Features

- Metalized polypropylene film capacitor.
- Rated voltage 275V (UL, C-UL 250V).
- Compact size.
- IEC/EN 60384-14: 2005 class X2.

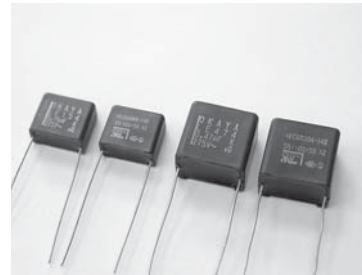
Before change to markings

After change to markings
